CITY OF EMERYVILLE

MEMORANDUM

SUBJECT: Study Session On Proposed Sherwin Williams Mixed Use Project

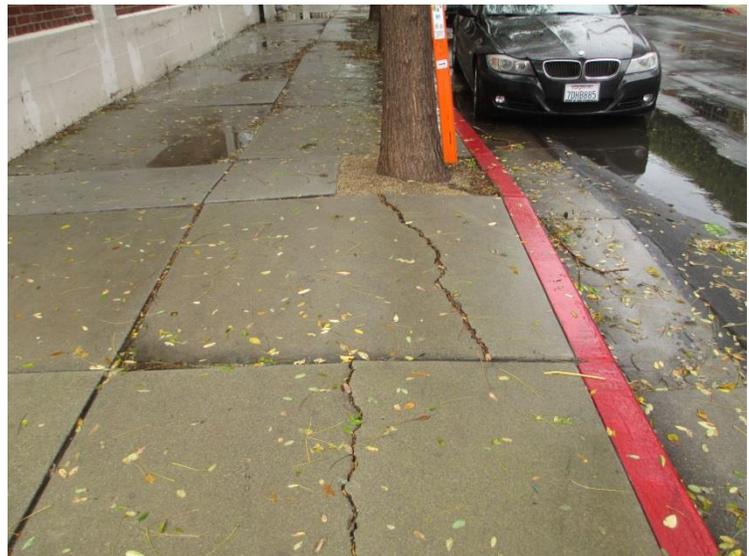
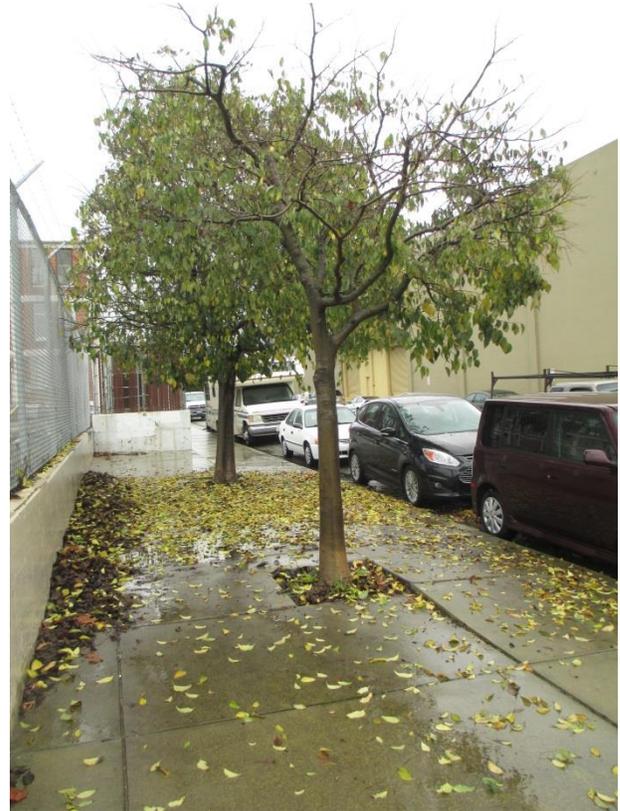
Photo 2. Photo to the left shows the sidewalk area having the most significant uplift. Because of the tree lean to the street, cutting the offending root may compromise the tree stability.

Photo 3. Photo to the right shows the Sophora tree closest to the corner of Sherwin St. Along with the sidewalk, the curb and street have been uplifted by the tree roots. Root pruning needed to accomplish the necessary repairs will likely compromise the future health and stability of this, the largest of the Sophora trees..

Photo 4. Photo to the left shows the bases of the two hackberry trees looking west with the larger tree in the foreground. The pavement uplift does indicate that the tree roots have developed near the surface, likely due to soil compaction.

Photo 5. Photo shows the hackberry trees looking east with the smaller tree in the foreground. This tree has not thrived, likely due to a restrictive soil environment. There is also sidewalk uplift.

Remove and replace all *Sophora* and smaller Hackberry. The larger Hackberry is a nice tree and maybe worthy of retention. However, without extensive soil and root mitigation, the hardscape displacement problems are expected to return. It is recommended that a suitable soil environment be provided for the replacement trees at or exceeding City guidelines for soil volumes and the use of structural soil.

OPTION A: STREET SECTIONS (PERIMETER)

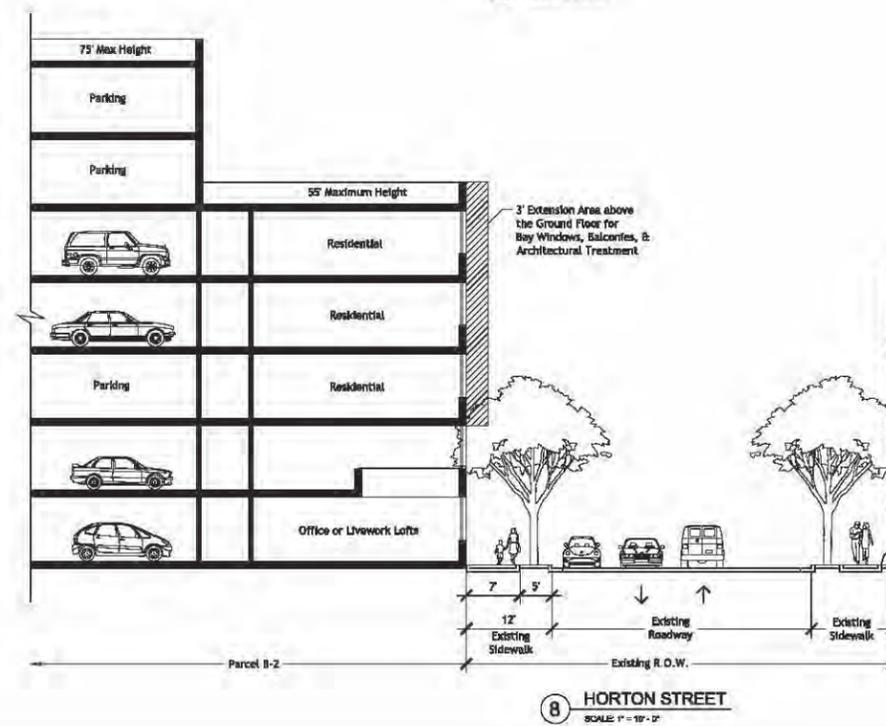
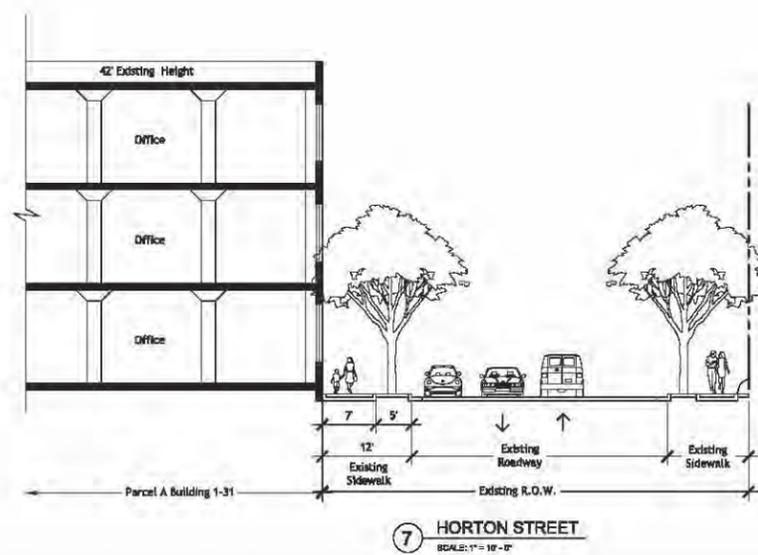
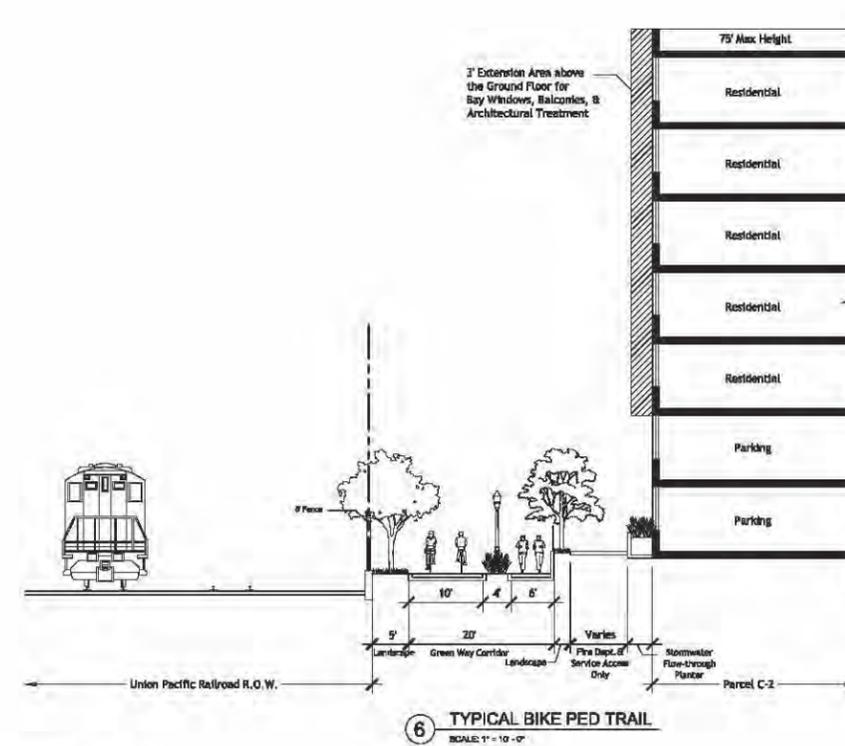
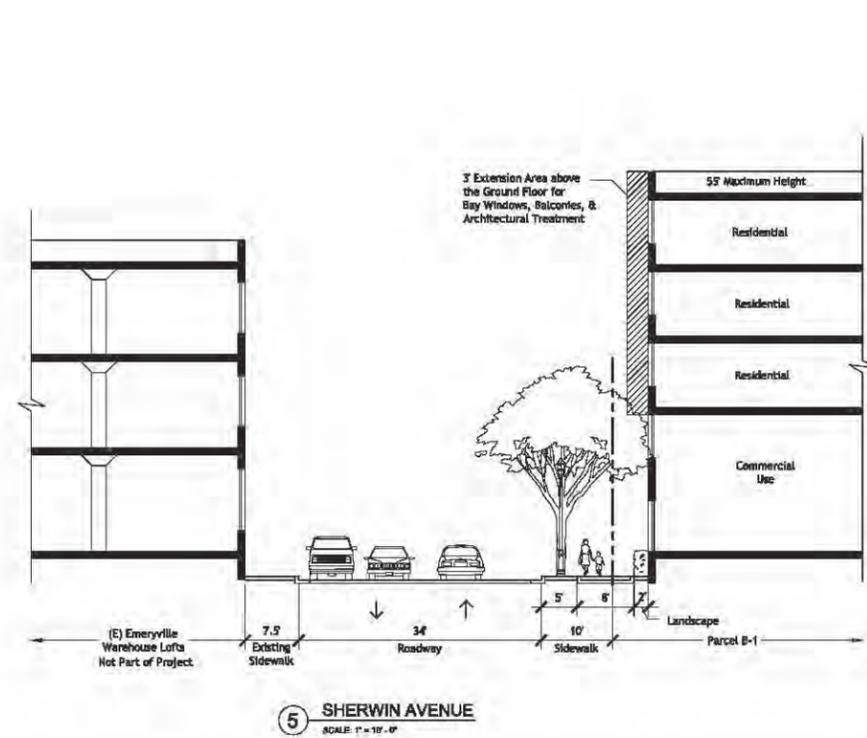
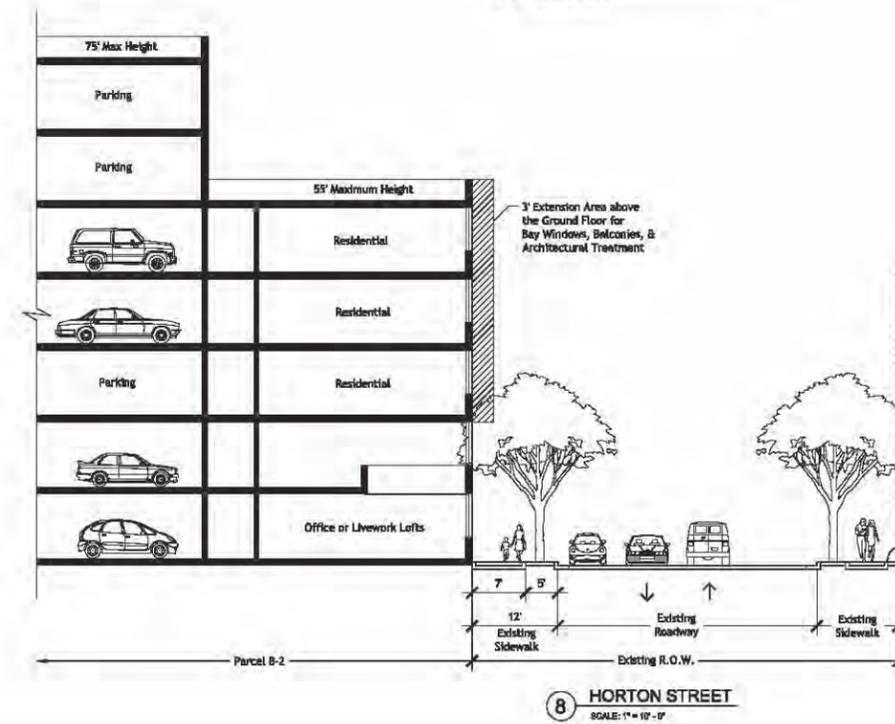
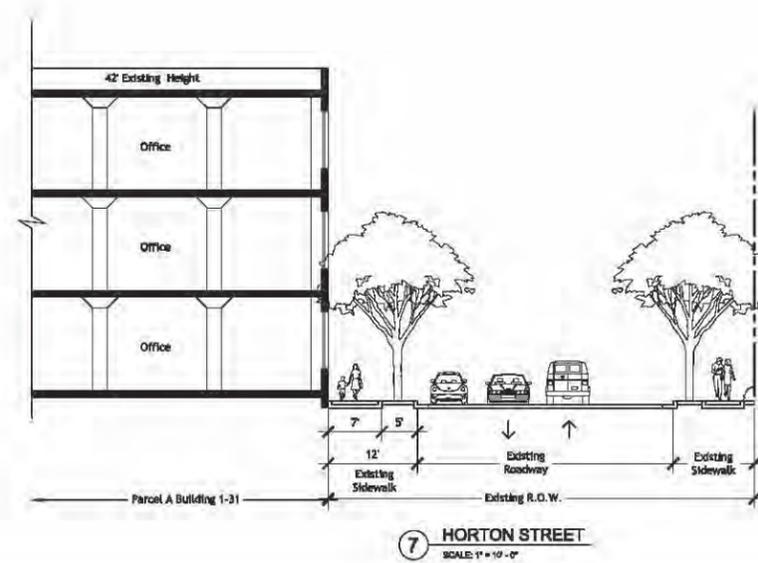
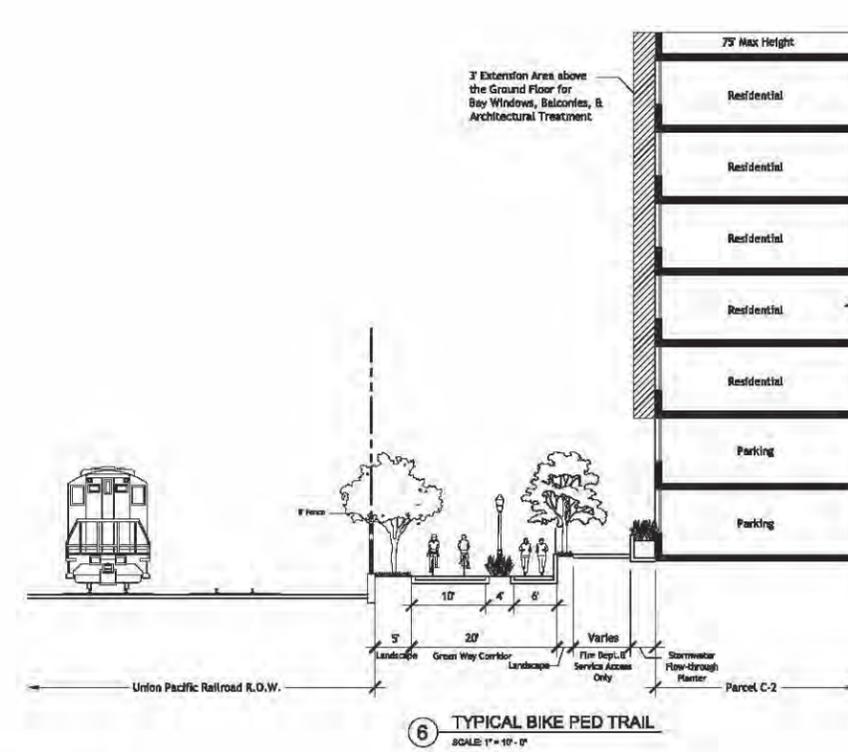
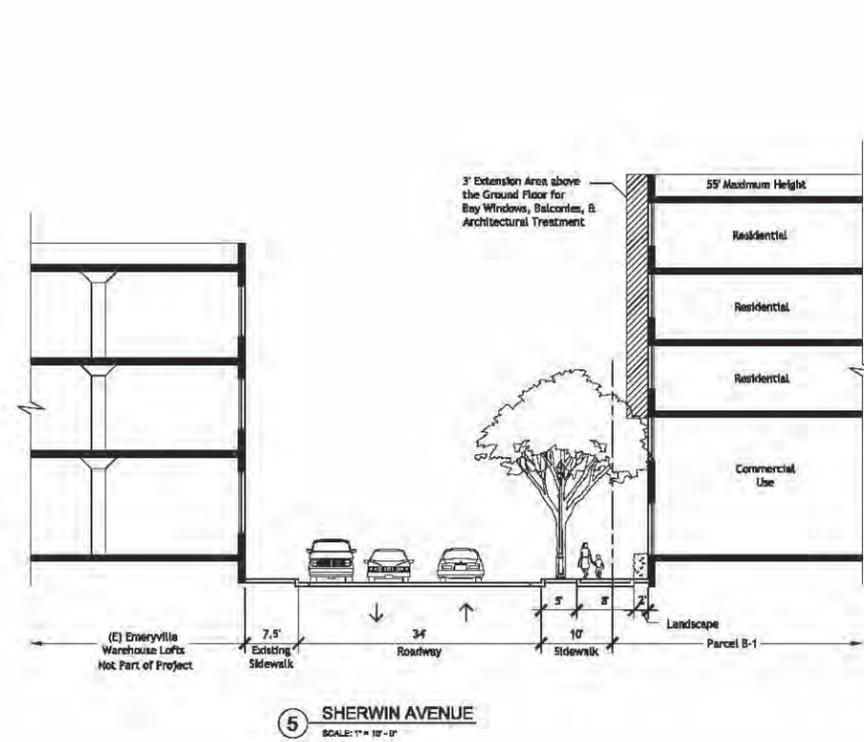
Pages 19 and 20 of attached plans provide street cross-sections for Option A. Except for the Hubbard Street entrance (Section 4), the sections for Option B on Pages 38 and 39 are identical to Option A. These sections allow an evaluation of the project's compliance with the Design Guidelines for sidewalk areas.

Generally, the Design Guidelines call for a minimum of 11.5 foot wide sidewalk, including 7.5 feet for a pedestrian pathway and 4 feet for a landscaped area between the pedestrian pathway and curb. Additionally, Sherwin Avenue, Hubbard Circle, and Horton Street between Sherwin Avenue and 45th Street are designated "Green Streets" that calls for a 15-foot minimum sidewalk corridor, including 8 feet for a pedestrian pathway, 5 feet for a landscaped area next to the curb, and 2 feet for a landscaped area next to the adjacent property (Figure 3-6 of Emeryville Design Guidelines). Where the Greenway is separate from a street, the Design Guidelines call for a 20 foot minimum corridor including a 10 foot paved pedestrian/bicycle pathway and a 6 foot unpaved path separated by 4 feet of landscaping (Figure 3-5 of Emeryville Design Guidelines). The proposal generally complies with these requirements.

It should be noted that, to comply with the Green Streets guidelines along Horton Street, it will be necessary to remove the existing street trees in order to widen the sidewalk area. The existing trees are large and mature and generally appear to be in good health. For this reason, the applicant proposes to preserve the existing trees. In that case, the Horton Street sidewalk would not comply with the design guidelines for Green Streets. The pedestrian pathway would actually be slightly wider than the 8 feet called for by the guidelines, but the planter strip between the roadway and pedestrian pathway would be too narrow, and there would be no planter strip next to the building. The City's consulting arborist has assessed the existing trees' health and condition. The findings are summarized in the attached report (please see Attachment 5). The arborist conclusion is that "this is an excellent opportunity to remove problematic trees and provide a tree root environment for replacement trees which will carry them long into the future without continual costly pavement repairs." The arborist will be present at the study session to respond to any questions. Based on the tree report and after hearing from the arborist, staff seeks the Council's direction as to whether to preserve the existing trees or remove them and redesign the Horton Street sidewalk to comply with the design guidelines for Green Streets.
